Subject: **Permit Addendum for Section 404 Nationwide Permits 14 & 33 and Section 401 Water Quality Certification and Neuse Buffer Certification** for US 1/64 From US 64/SR 1009 (Tryon Road) Interchange to South of I-40 in Cary, Wake County; TIP No. U-3101C & D; State Project No. 8.1403101; Federal Aid Project No. STPNHF-1(4); USACE Action ID Nos. 200120922 & 200421562; NCDENR-DWQ Project No. 041055; WBS Element 34897.1.1.

The North Carolina Department of Transportation (NCDOT) – Division 5 has recently completed a pre-let environmental review associated with the widening of US 1/64 from US 64/SR 1009 (Tryon Road) Interchange to south of I-40 in Cary, Wake County. The pre-let review was based on the final roadway construction plan sheets and permit drawings that were attached to the permit applications dated June 18, 2004 and August 31, 2004.

The review identified all permit drawing and plan sheet discrepancies, as well as other associated constructability concerns that could be identified during the pre-let phase of this project. This Permit Addendum addresses the identified discrepancies and provides the

NCDOT
DIVISION OF HIGHWAYS
WAKE COUNTY
PROJECT: 8.1403101 (U-3101)
US 1/64 FROM US 1/64/SR1009
(TRYON RD.) INTERCHANGE TO
SOUTH OF I-40 IN CARY
SHEET 13 OF 21
rev. 2-25-05
6-11-04

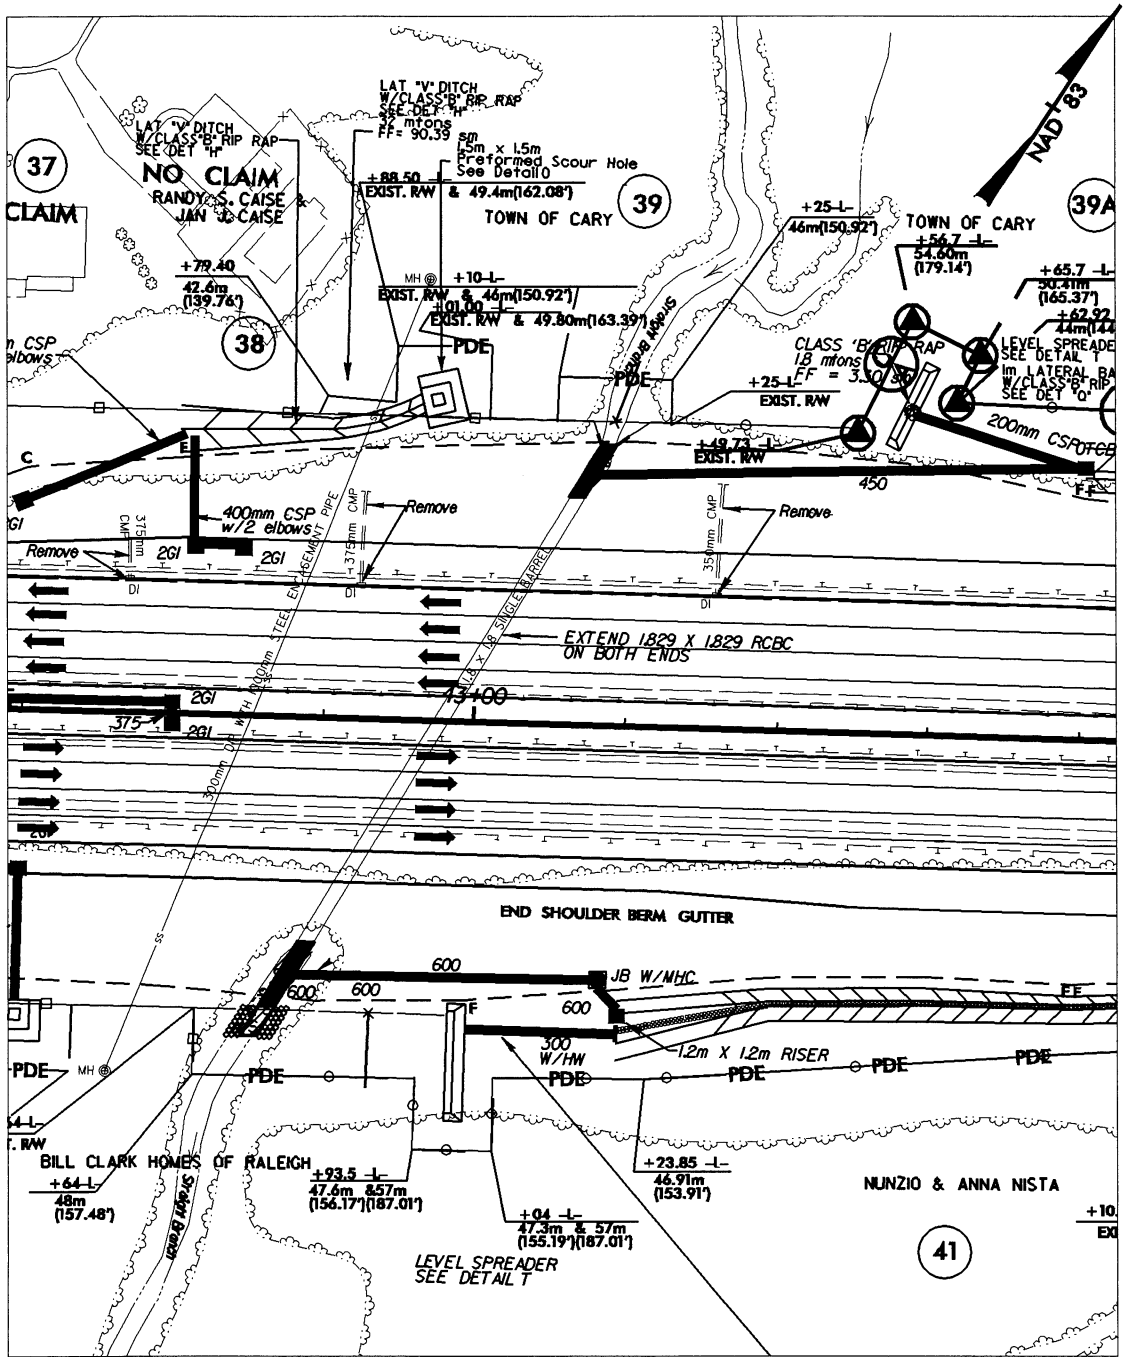
5. Replace permit drawings Sheet 13 of 21 (stream drawing) and Sheet 12 of 19 (buffer drawing) with revised Sheet 13 of 21 (rev. 2-25-05) and Sheet 12 of 19 (rev. 2-25-05), respectively. These actions will allow for the depiction of 2GI at Station 42+68 Left, which was not included on the original drawings. NOTE: no additional stormwater will be added to the PFSH via the drainage system.

US 1/64 FROM US 1/64/SR1009
 (TRYON RD.) INTERCHANGE TO
 SOUTH OF I-40 IN CARY
 rev. 2-25-05
 08-27-04
SHEET 184 OF 21

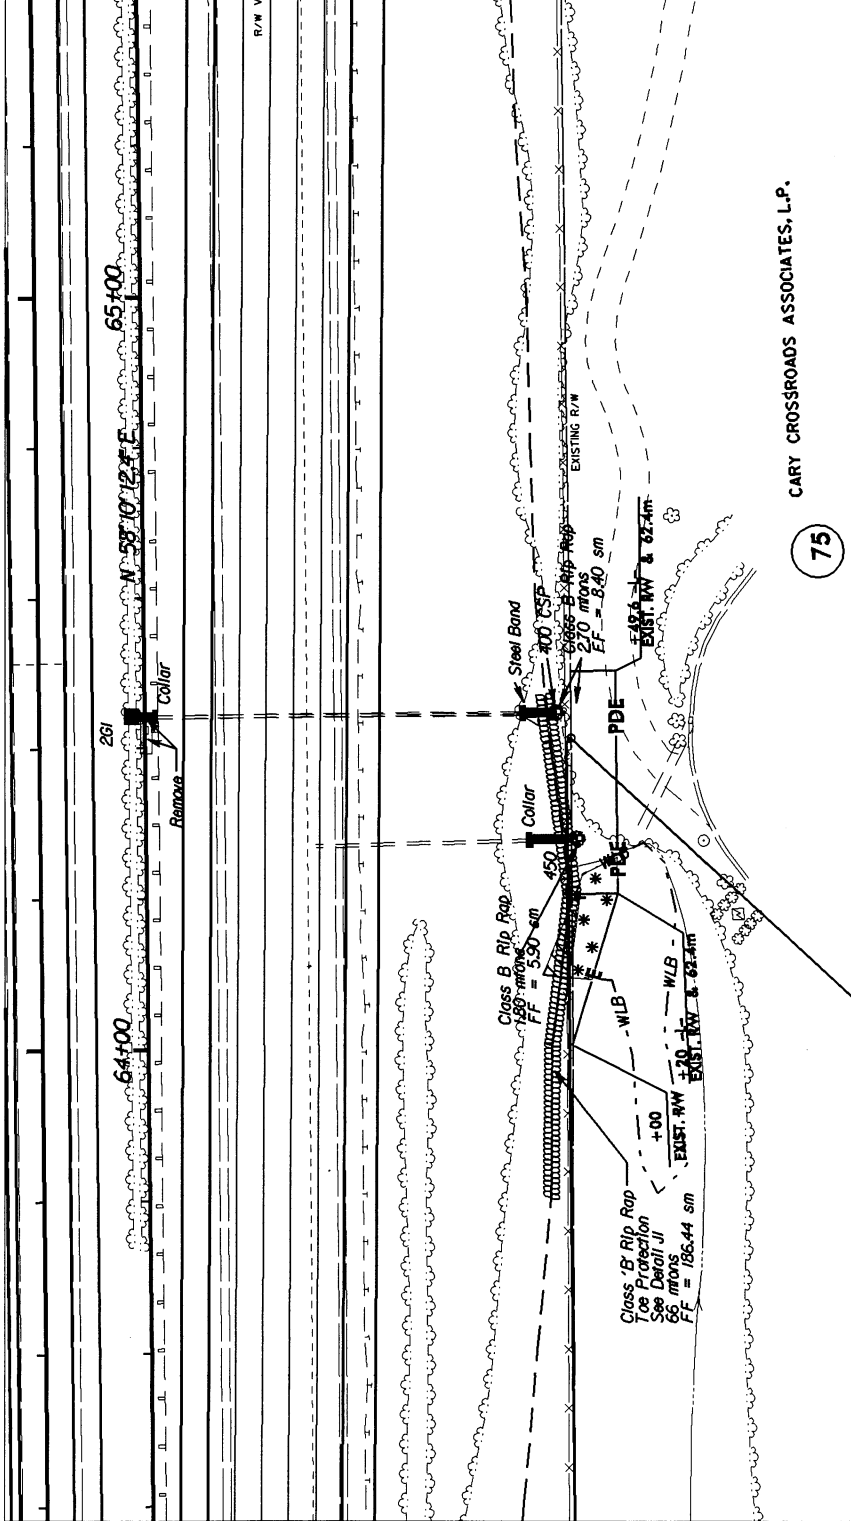
6. Replace permit drawing Sheet 18A of 21 with revised Sheet 18A of 21 (rev. 2-25-05). This action will allow for the inclusion of a reference for Detail J1 (installation of toe wall protection), which was not included on the original drawing. The addition of Detail J1 has been incorporated on to Plan Sheet 2-UU, which has already been noted to be included with the attachments (see Item No. 2).

FAIRFIELD PUMP STATION
ABANDONMENT PROJECT
 STA. 22+00 TO STA. 34+00
PLAN & PROFILE

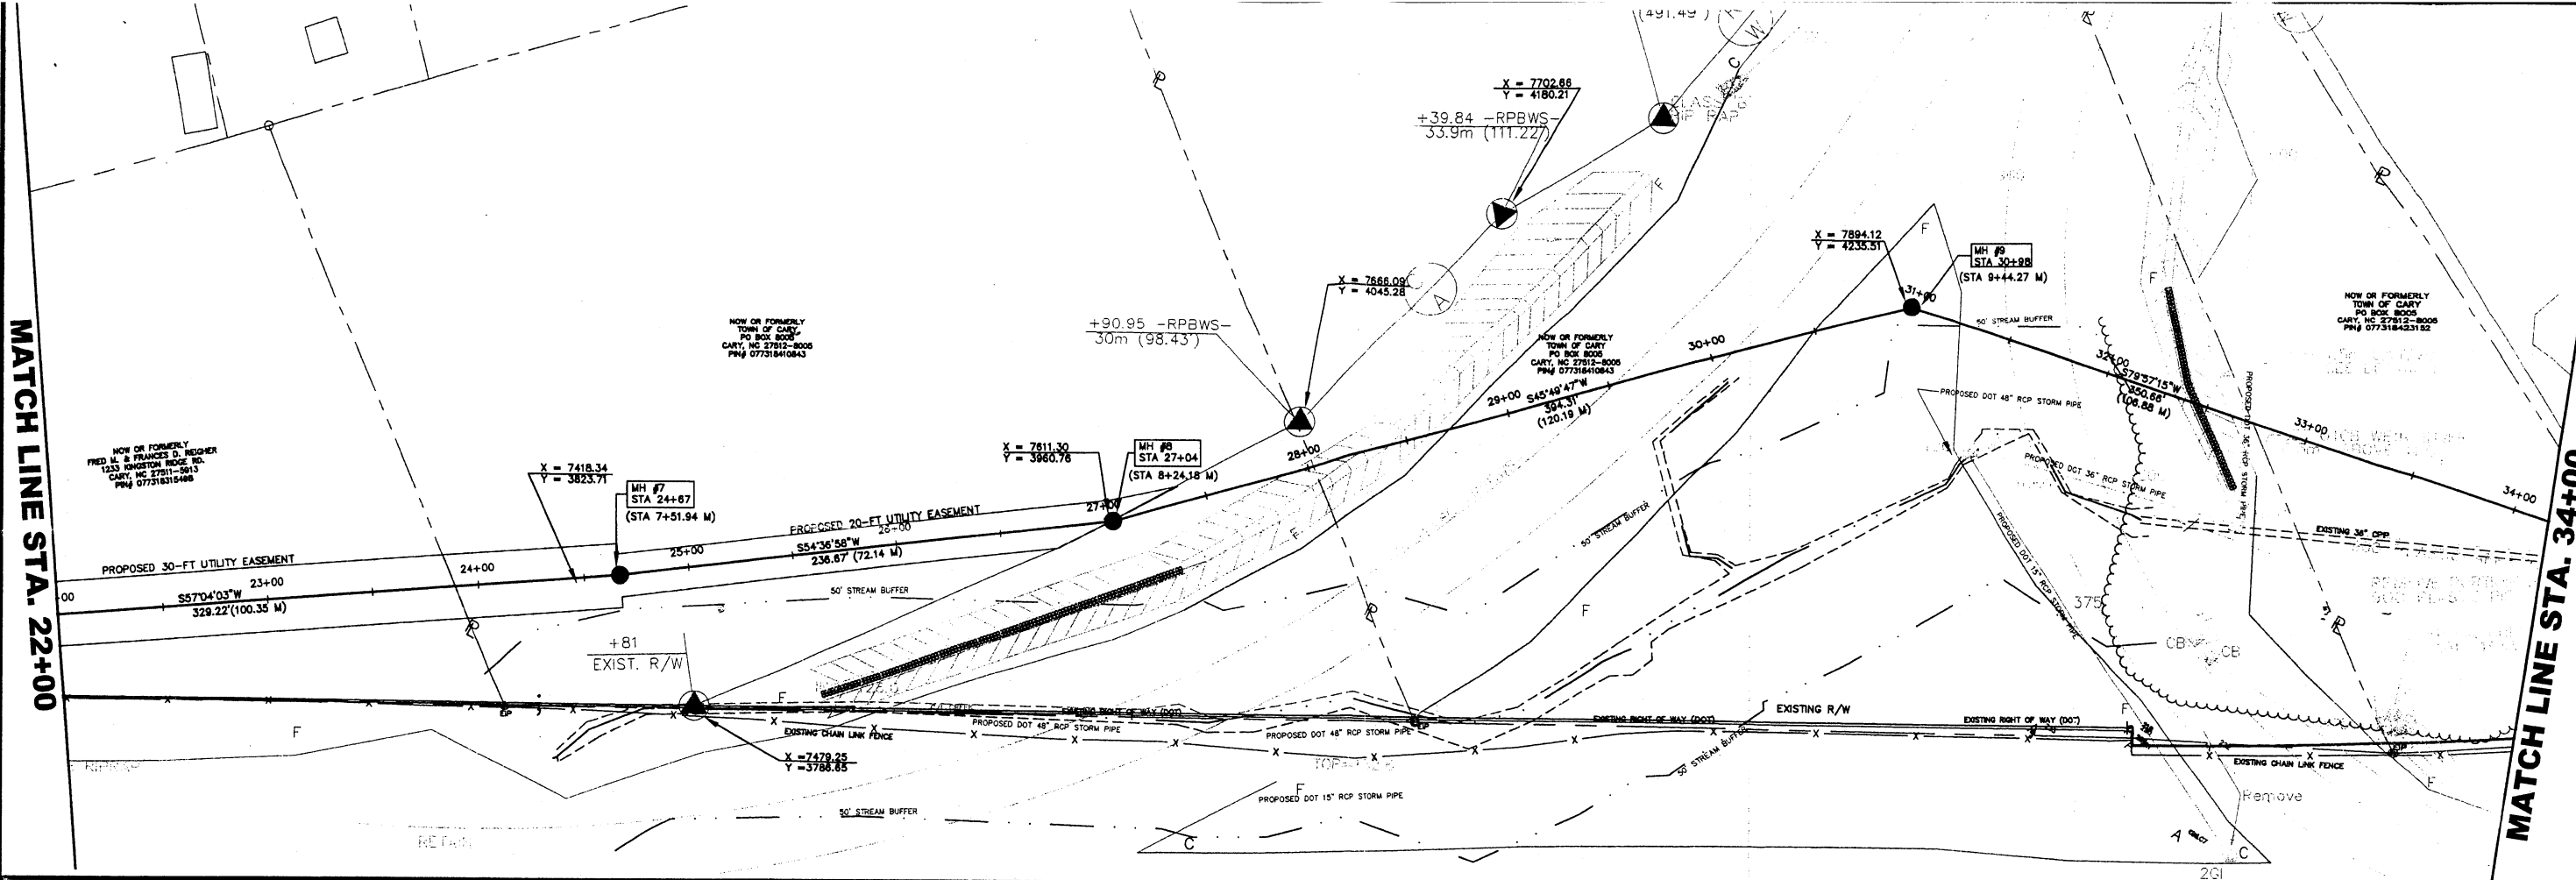
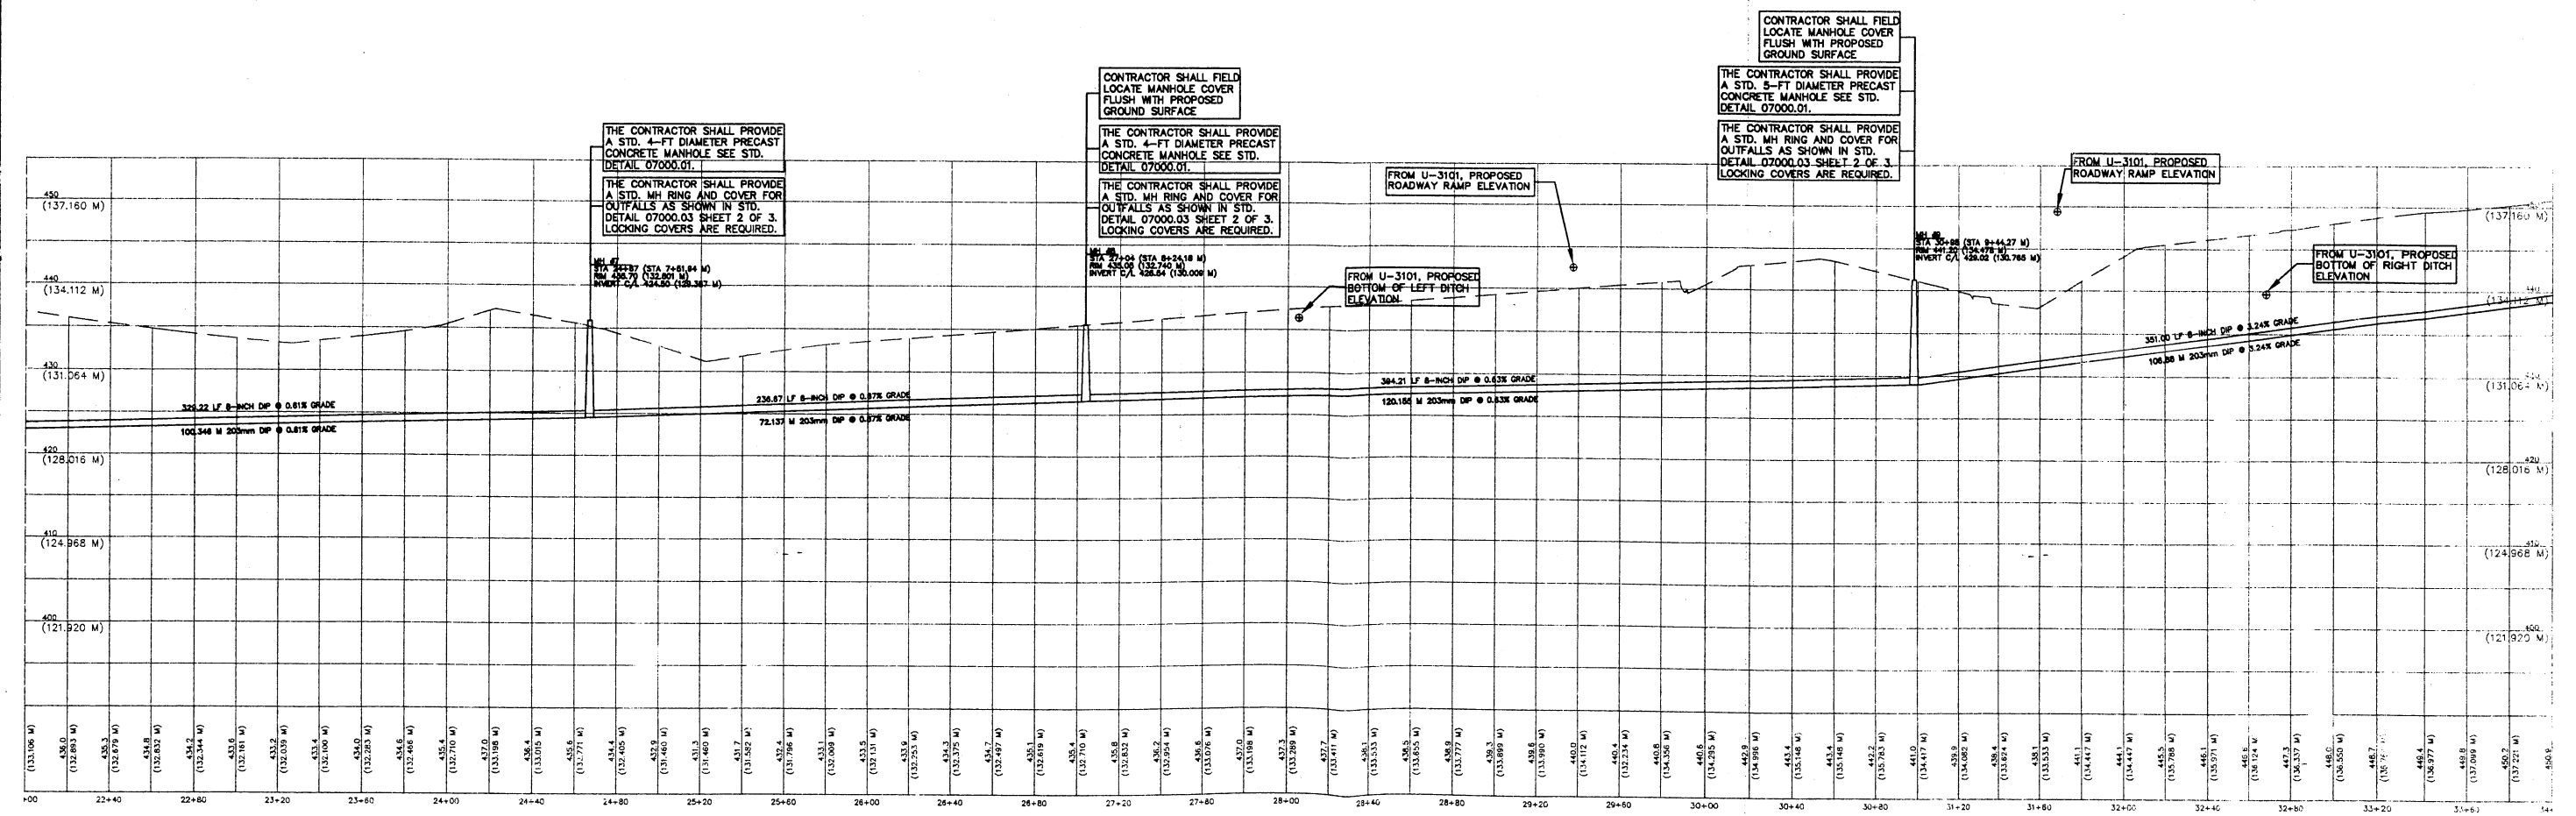
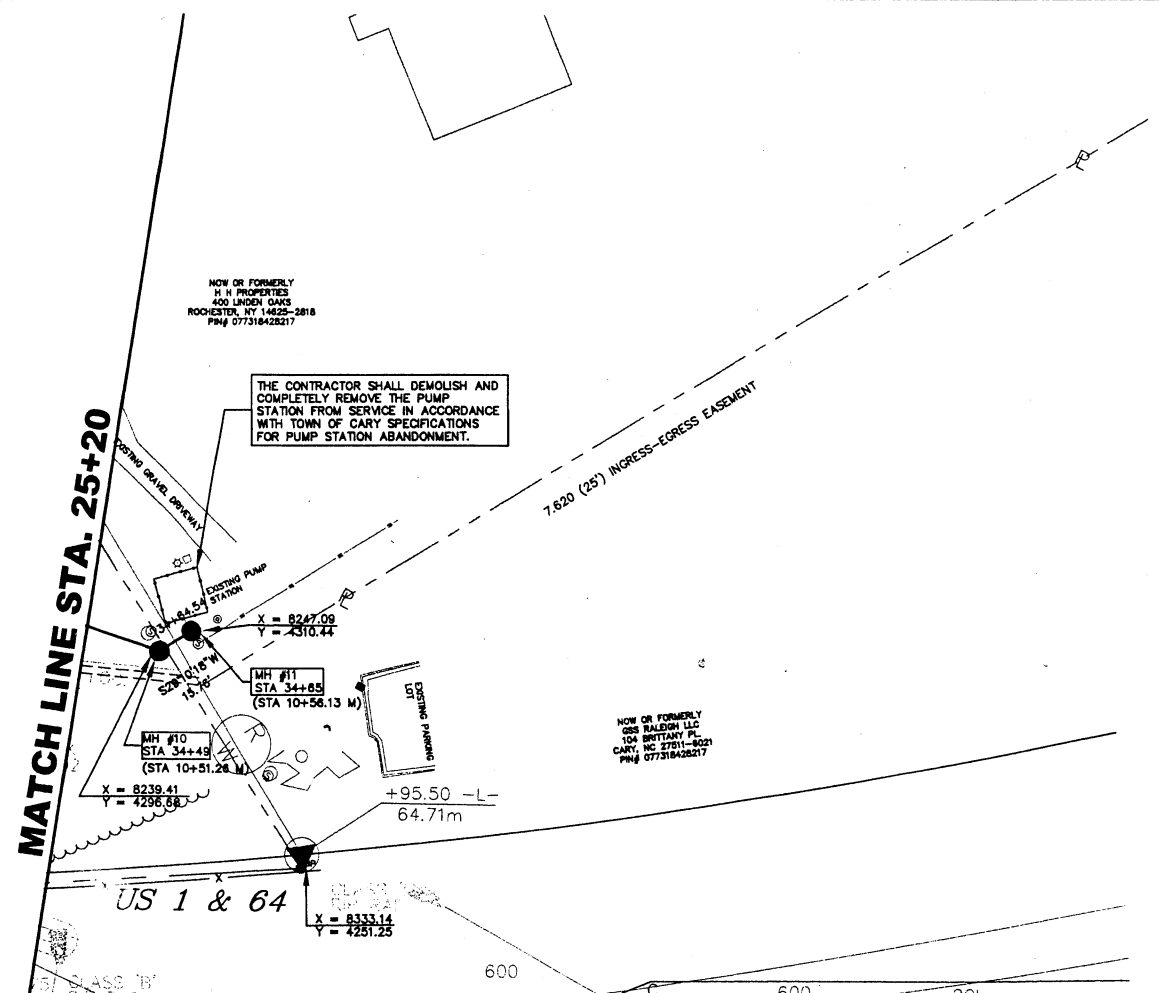
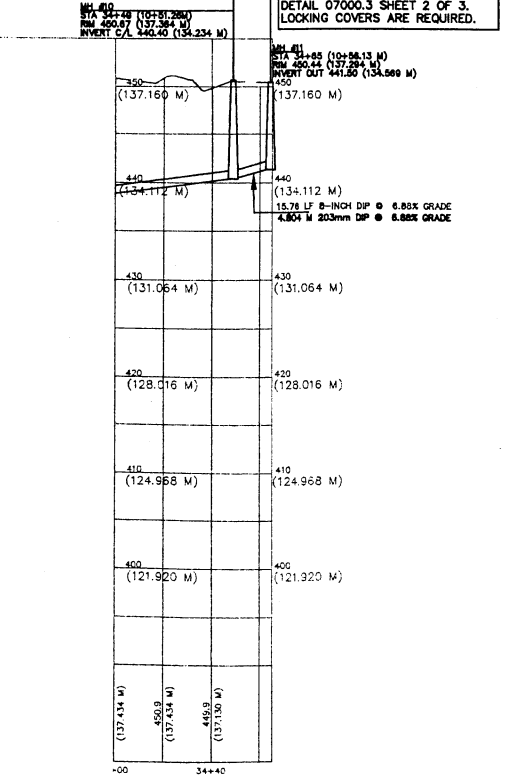
7. Replace Fairfield Pump Station Plan & Profile Sheets 3 of 5 and 4 of 5 with revised Fairfield Pump Station Sheets 3 of 5 and 4 of 5 (rev. 2-7-05). The drawing revision depicts the new location of a manhole and sewer line. No new riparian buffer impacts will result from the shift of the manhole and sewer line.

2-7-05 REVISED MANHOLE #9 - J.S.M

REVISIONS
 Relocated manhole
 # 9 as requested
 by DOT.
 12 Jan 2005.
